ADDENDUM NO. 2

September 9, 2022

CROWN POINT HIGH SCHOOL ATHLETIC FIELDS AND SITE IMPROVEMENTS
Crown Point, IN 46307

ADDENDUM TWO

SHEET C-2.2

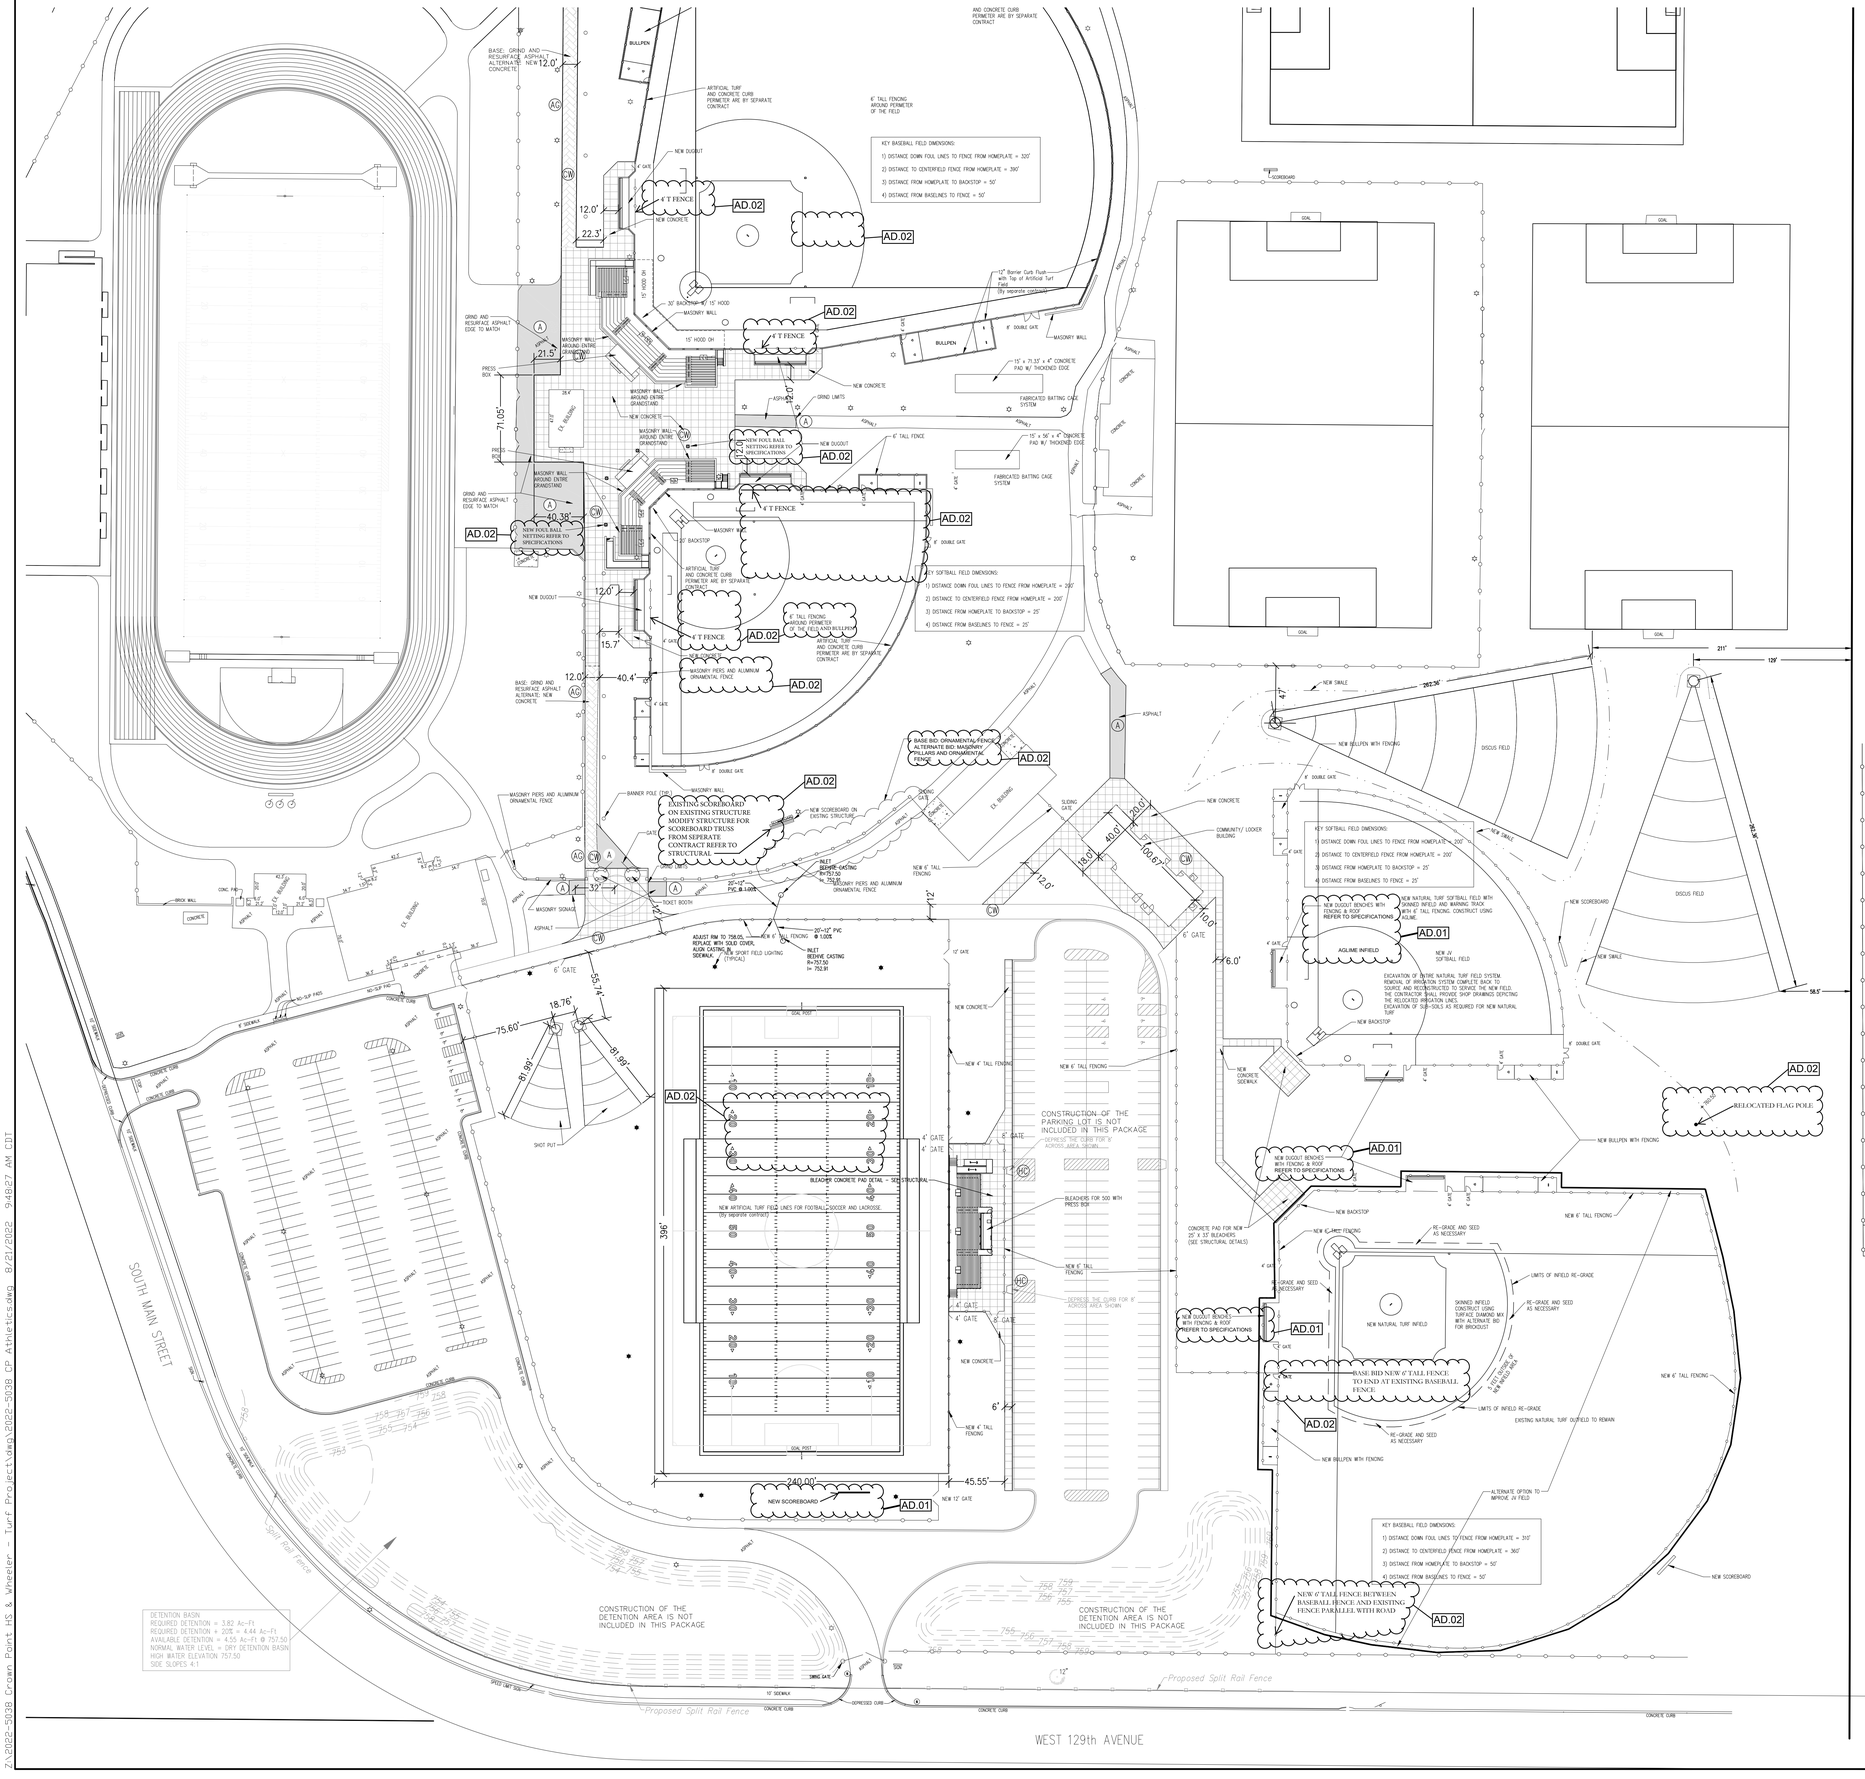
6. Sheet C-2.2

A. Refer to revised, full-size drawing, included in this Addendum, for revised plan notes as indicated on drawing.

SHEET
C-3.1

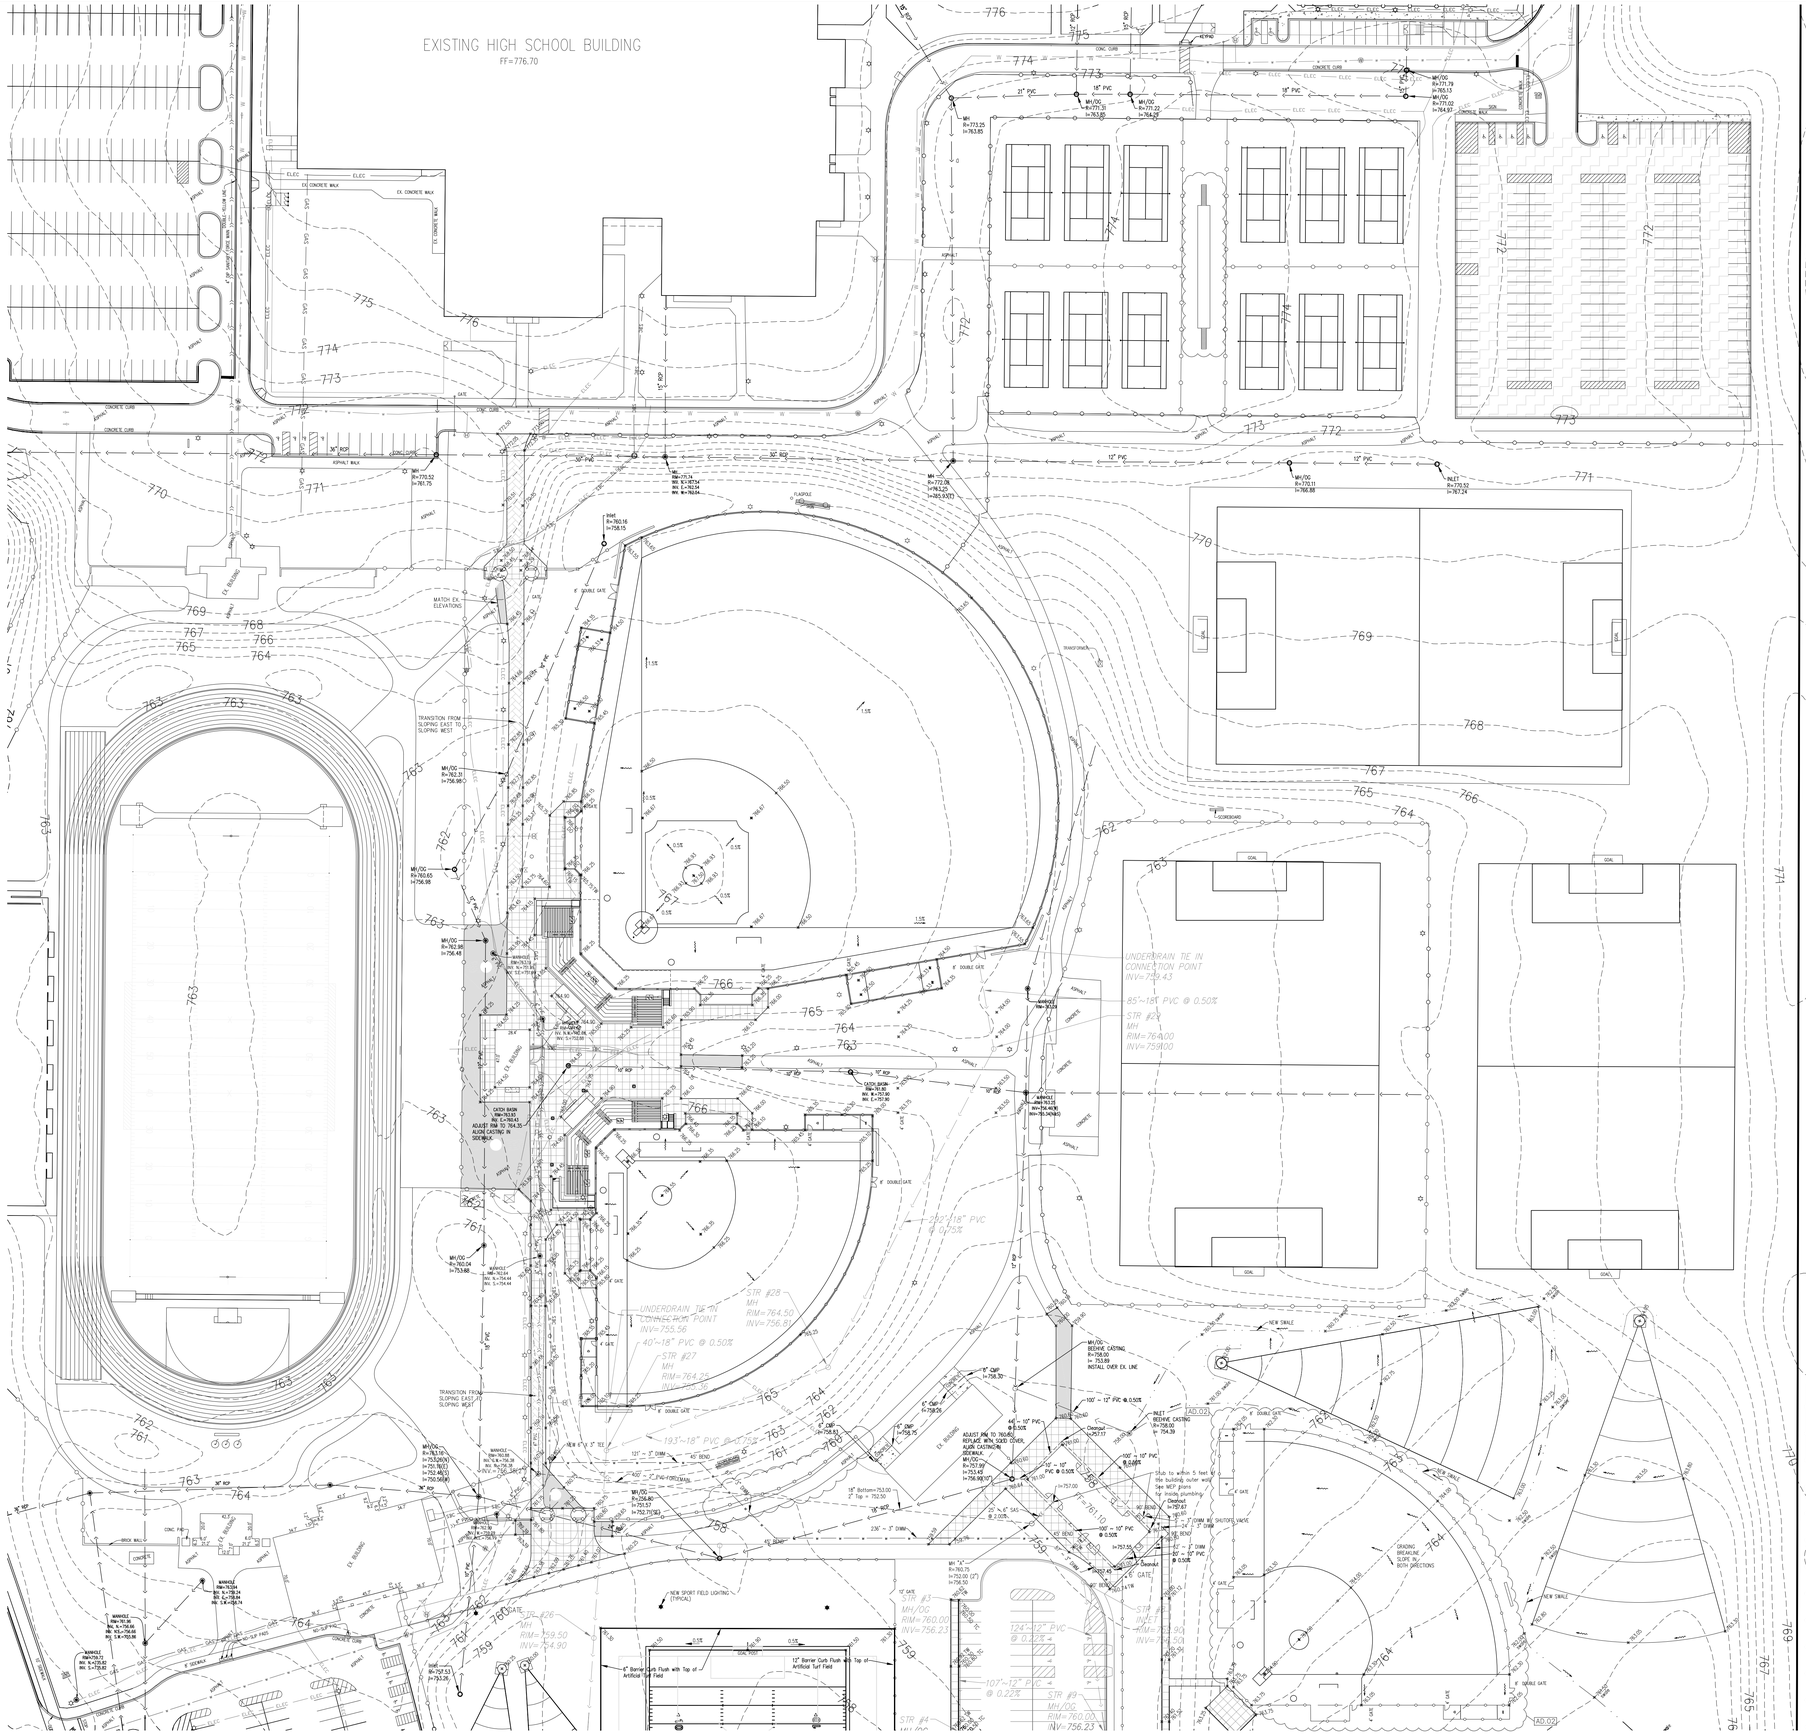
7. Sheet C-3.1

A. Refer to revised, full-size drawing, included in this Addendum, for regrading of the JV Softball Field.

SHEET
C-3.2

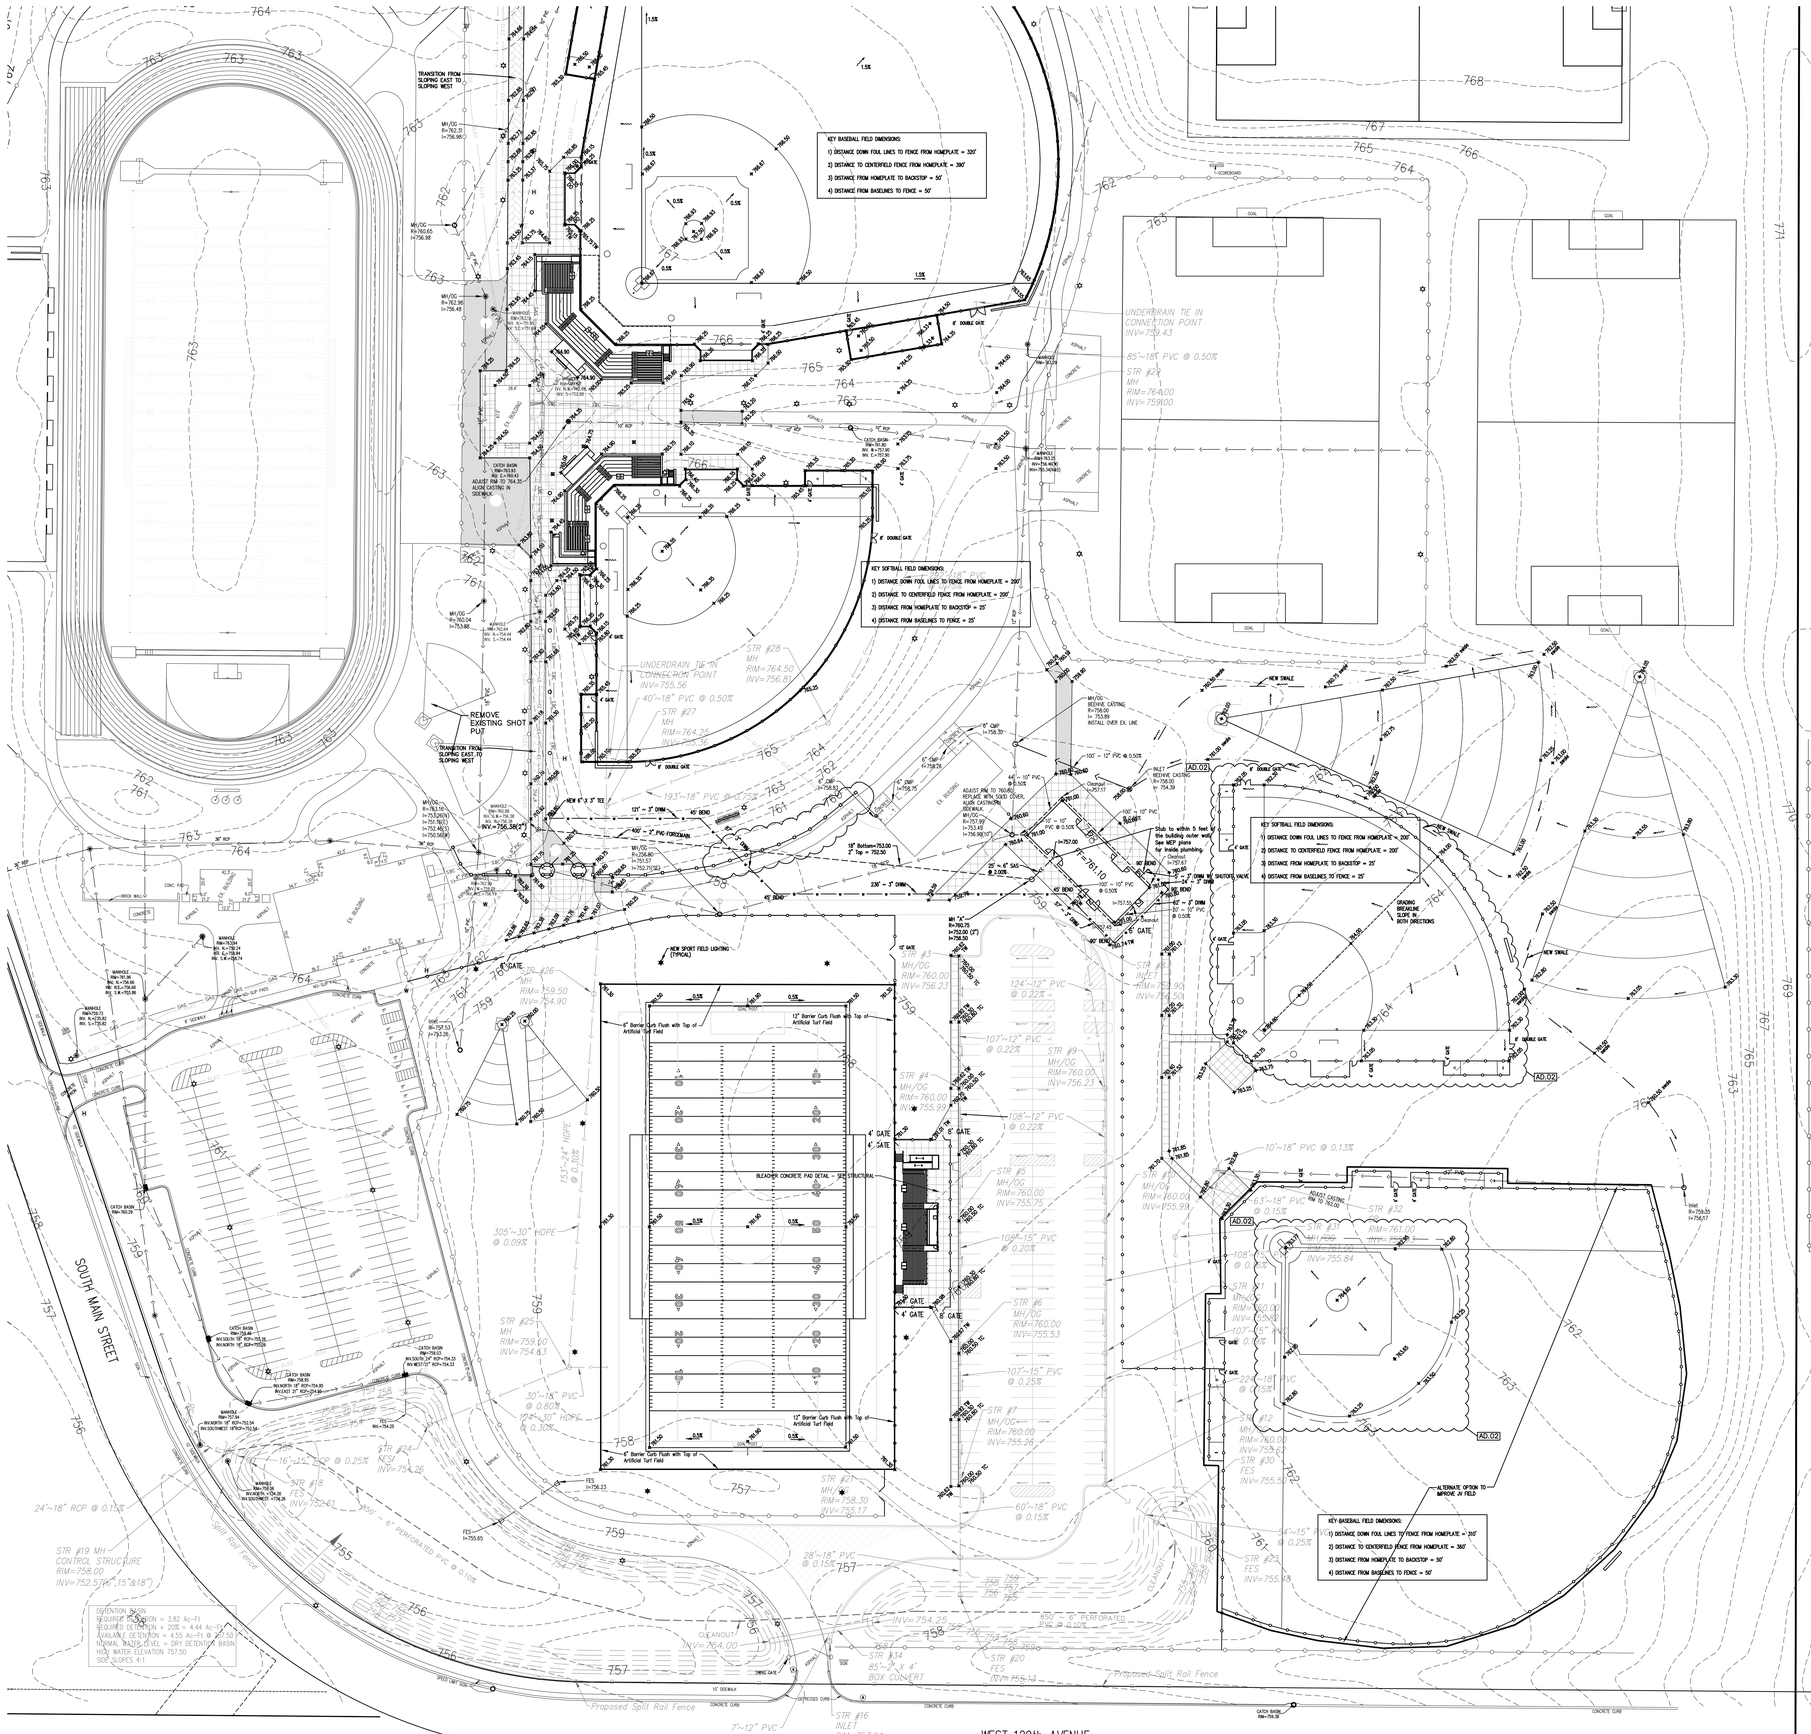
8. Sheet C-3.2

A. Refer to revised, full-size drawing, included in this Addendum, for regrading of the JV Softball Field and the JV Baseball field Infield.
